**CALIFORNIA COASTAL COMMISSION**

**STAFF REPORT:**  
**PERMIT AMENDMENT**

**APPLICATION NO.:** A-1-MEN-01-043-A1

**APPLICANTS:** KEN AND JILL ROOST

**A1.2**

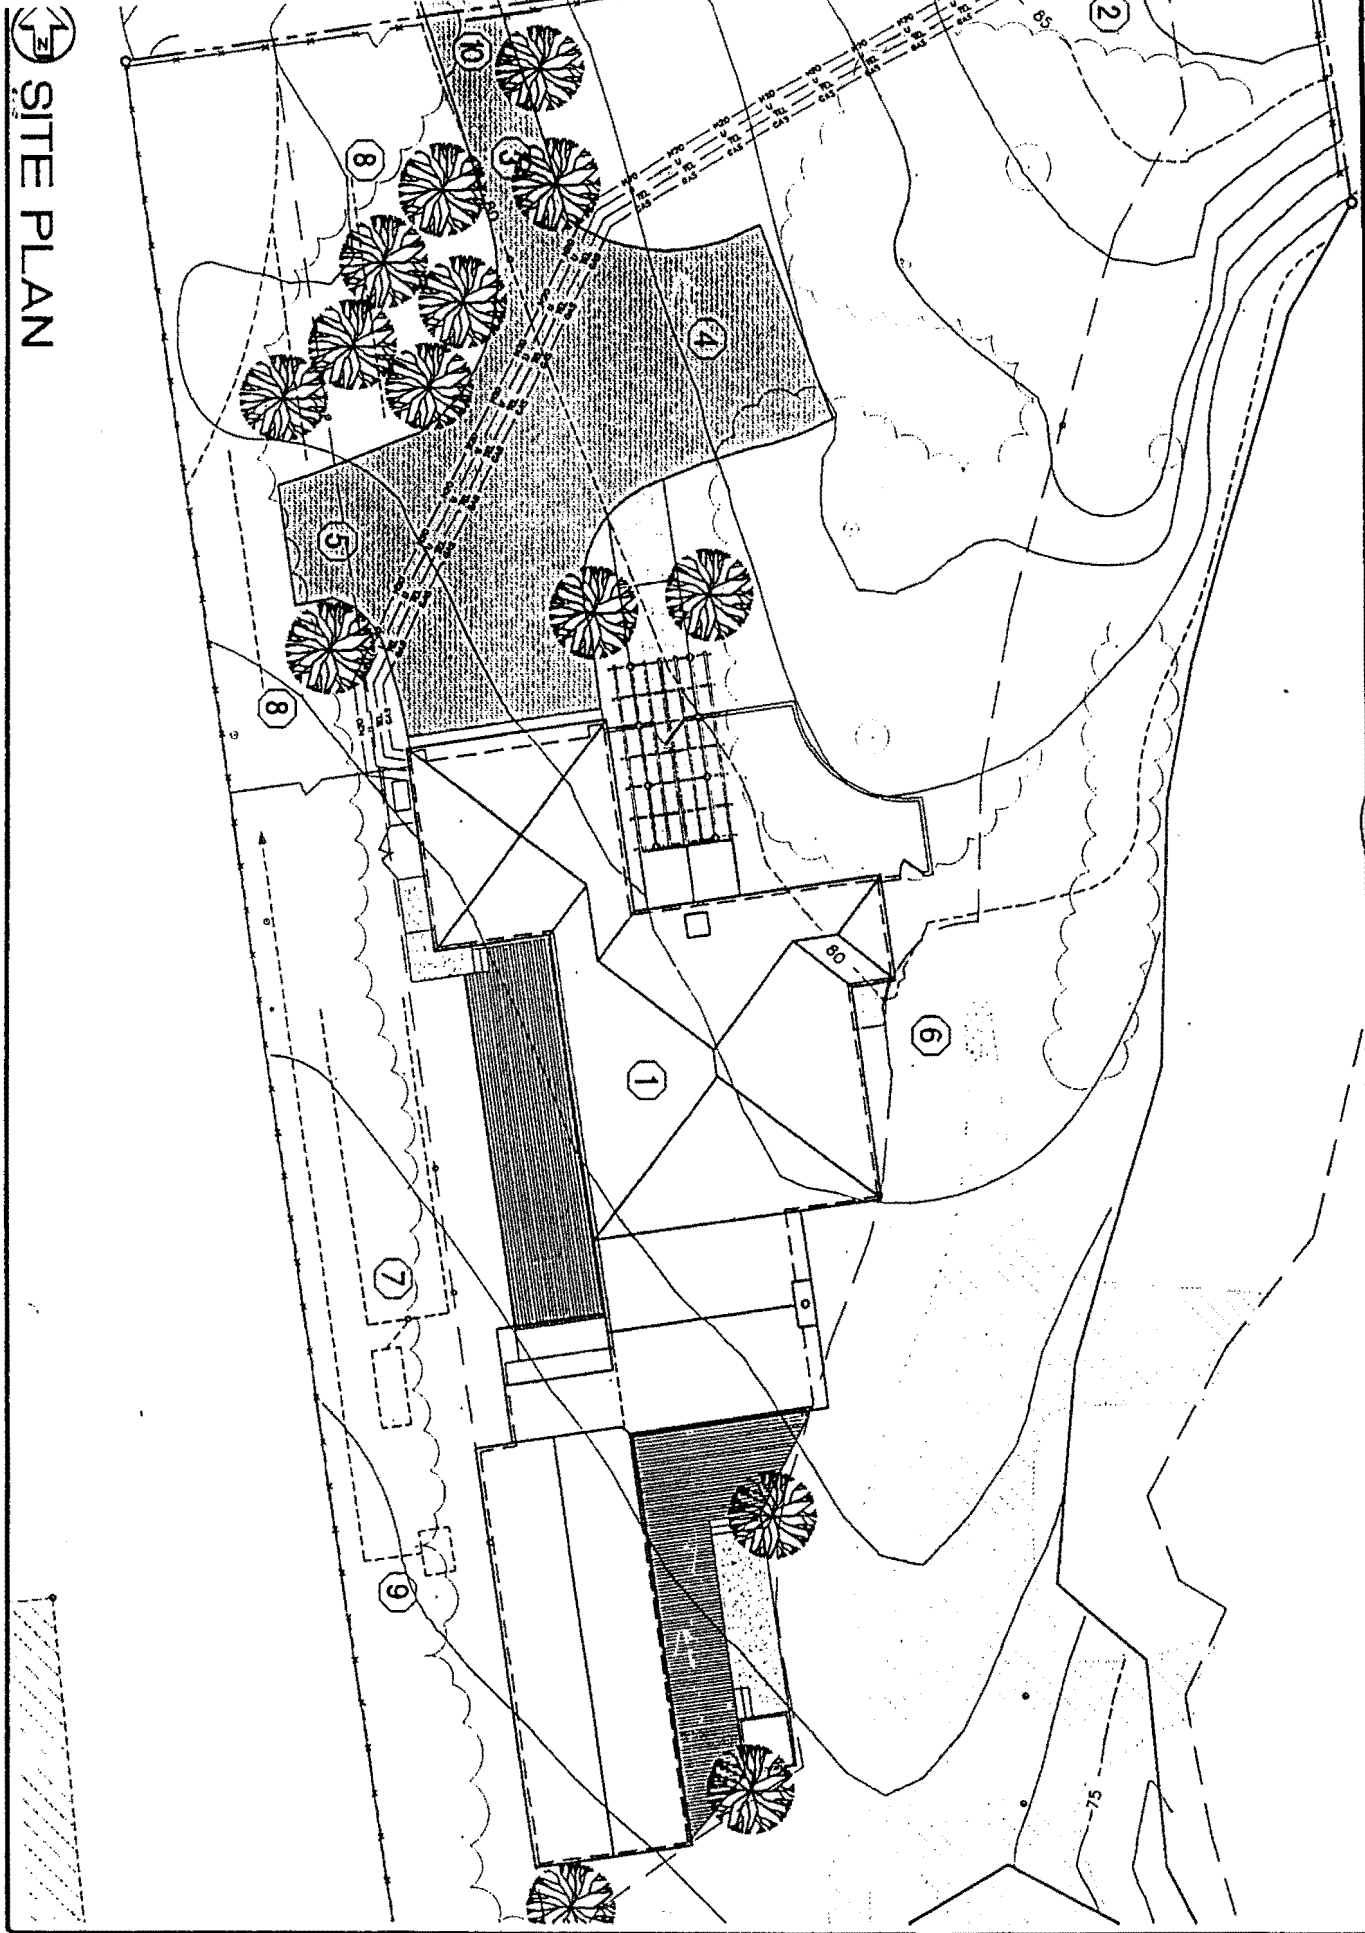
*life spans.*” Therefore, the Commission includes in the requirements of Special Condition No. 8 that the applicants submit a revised site plan for the review and approval of the Executive Director that shows the proposed fencing setback at least 25 feet from the bluff top as well as an additional ten feet from the blufftop sea cave wall projection to conform with the bluff setback requirements of LUP Policy 3.4-7.

The Commission includes within Special Condition No. 8 a requirement that the applicants submit for the review and approval of the Executive Director a revised site plan that would eliminate the fencing within the geologic setback areas. As conditioned, the Commission finds that the proposed fencing is consistent with the requirements of LUP Policies 3.5-1 and 3.5-3 and Coastal Zoning Code Sections 20.504.015 that new development in highly scenic areas be subordinate to the character of its setting.

### LANDSCAPE PLAN

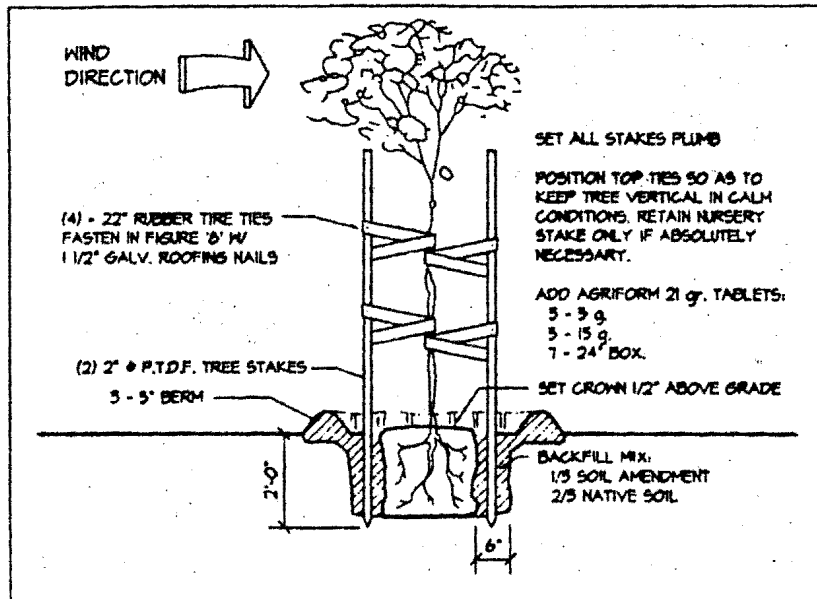
As stated above, the submitted landscaping plan (Todd Newberger Environmental Design, undated) indicates that three shore pine and four coast silk-tassel trees would be planted along the southeast portion of the residence to partially screen the structure from

public view. However, the landscape plan site map illustrates the locations of only three such silk-tassel trees. To resolve this inconsistency, the Commission includes within Special Condition No. 8 a requirement that the applicants prepare and submit for the review and approval of the Executive Director a revised landscaping plan site map indicating the location of all landscape plants described within Landscape Note No. 2 of the preliminary plan. Special Condition No. 8 also specifies that the trees be planted in a certain arrangement on the property to maximize the softening affect they may have on the appearance of the development. In addition, as proposed by the applicants, the landscaping plan includes a provision that will ensure that the trees are maintained and replaced if they die over the life of the development.
